APPLICATION NO.	FILING DATE	FIRST NAMED INVENTOR	ATTORNEY DOCKET NO.	CONFIRMATION NO.
10/622,960	07/18/2003	Ralph D. Geater	GEAT100USA	4002
24339	7590	05/12/2004	EXAMINER	
JOEL D. SKINNER, JR. SKINNER AND ASSOCIATES 212 COMMERCIAL ST. HUDSON, WI 54016			SZUMNY, JONATHON A	
			ART UNIT	PAPER NUMBER
			3632

This is the first office action for application number 10/622,960, Fastener Technology, filed on July 18, 2003.

Claims 1-6, 9-12 and 16-18 are rejected under 35 U.S.C. 102(b) as being anticipated by U.S. Patent number 4,865,281 to Wollar.

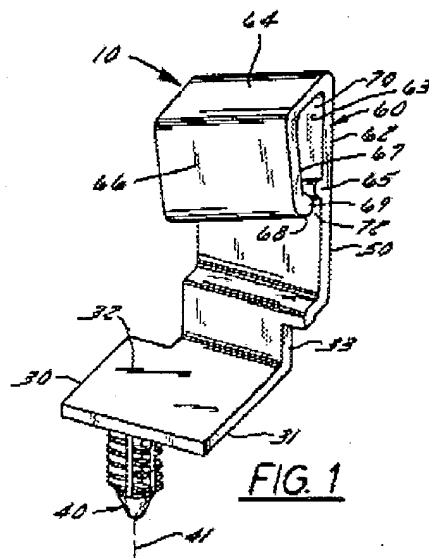
Wollar '281 discloses a unitary/plastic device (above, column 3, lines 45-46) comprising a rectilinear frame (50,33 generally), a leg (30) communicatively connected to the frame, and an curvilinear arm (64,66, it is curvilinear at where "10" is pointed in figure 3) connected to the frame and defining a passage (70) in which an article (14) is disposed; wherein the frame has first and second ends (near 33 and near 64, respectively) and a predetermined length, wherein the leg has a predetermined configuration with a predetermined area and depends from the first end of the frame at a right angle thereto, wherein the device includes connecting means (40), wherein the device could inherently attach to a wall stud, wherein the arm depends from the second end, wherein the arm is flexible (see column 3, lines 45-46), wherein can inherently be separated a predetermined distance from an external base object (see figure 3), wherein the article is an electrical cable (14, column 3, lines 29-30, "insulated flexible electric wires").

Claims 1, 4-8, 10, 11 and 13 are rejected under 35 U.S.C. 102(b) as being anticipated by U.S. Patent number 4,915,125 to Lester.

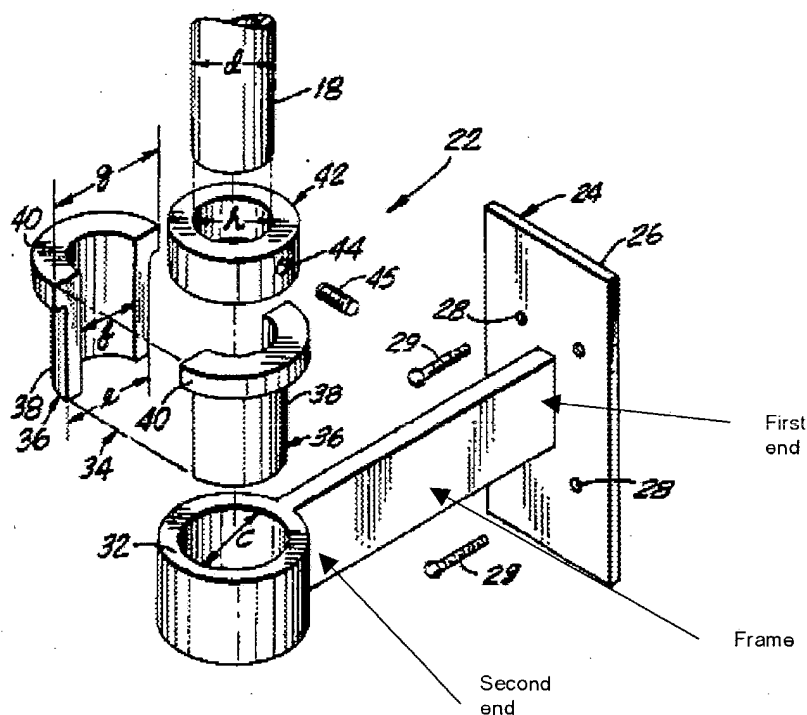
Lester '125 discloses a device (above) comprising a frame (above), a leg (24) communicatively connected to the frame, and a curvilinear arm (32) connected to the frame and defining a cylindrical passage (within 32) in which an article (18) is disposed, wherein the frame has a rectilinear configuration with first and second ends (above) and a predetermined length, wherein the leg has a predetermined configuration with a predetermined area and depends from the first end of the frame at a right angle thereto, wherein the device includes connecting means consisting of a screw (29) wherein an aperture (28) is disposed at a predetermined location in the leg, wherein the arm

depends from the second end, wherein the passage has open ends through which the article is disposed.

Claims 1-5, 10-12, 14, 15 and 19 are rejected under 35 U.S.C. 102(b) as being anticipated by U.S. Patent number 6,206,331 to Keith et al.

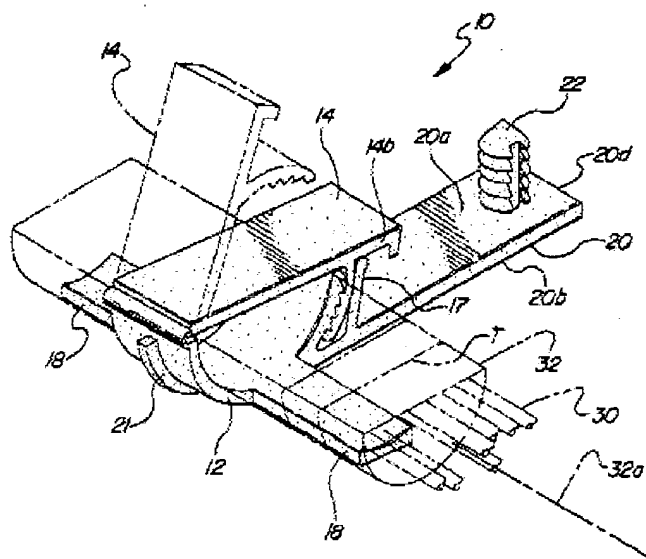
Keith et al. '331 discloses a unitary/plastic device (above) comprising a rectilinear frame (12,20), a leg (22) communicatively connected to the frame, and a flexible curvilinear arm (14,16, it is curvilinear at 16, it is flexible at 14a) connected to the frame and defining a passage (within 14,16) in which an article (30) is disposed; wherein the frame has first and second ends (near 20d and near where "21" is pointed in figure 2, respectively) and a predetermined length, wherein the leg has a predetermined configuration with a predetermined area and depends from the first end of the frame at a right angle thereto, wherein the arm depends from the second end, wherein a lock

member (12a) is connected to the frame, wherein the arm has a locking end (16a) which releasably mates (see column 2, lines 60-64) with the lock member, wherein the lock member and locking end have complementary mating notches (between teeth), wherein the arm also has a rectilinear configuration (top of 14) defines a substantially cylindrical passage (inside of 16) with open ends, wherein the arm has a free end (tip of 16) couplable to the lock member.

Claim 20 is rejected under 35 U.S.C. 102(b) as being anticipated by U.S. Patent number 6,079,674 to Snyder.

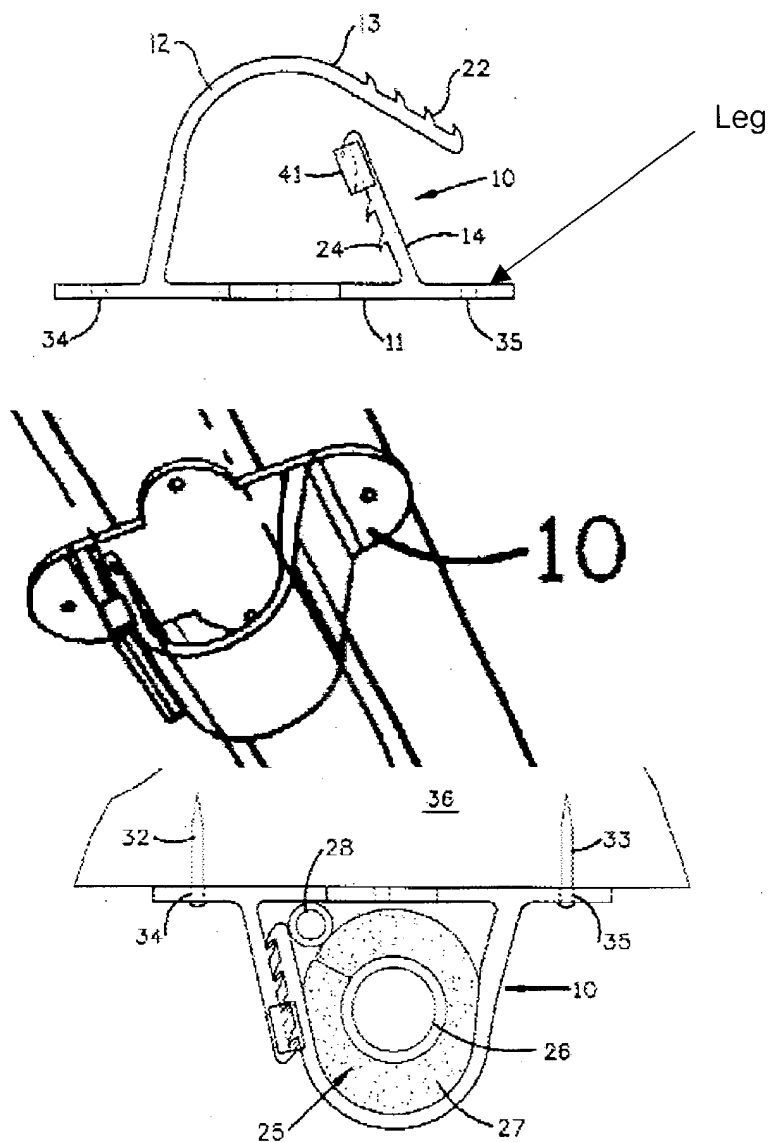
Snyder '674 discloses a system (figure 1) comprising a rectilinear frame (11, from bottom of 12 to bottom of 14) with first and second ends (near bottom of 14, near bottom of 12, respectively) and a predetermined length, a leg (above) communicatively connected to the frame at the first end and having an aperture (35) disposed at a predetermined location thereon, a nail (33), a lock member (24) connected to the frame at a predetermined location and having a mating notch (between each 24), and a

flexible arm (12) connected to the arm at the second end, the arm having a curvilinear configuration defining a substantially cylindrical passage (within 12) with open ends, the arm having a free end (13) with a mating notch (between each 22) which is releasably couplable (see column 4, lines 15-16) to the mating notch of the lock member.
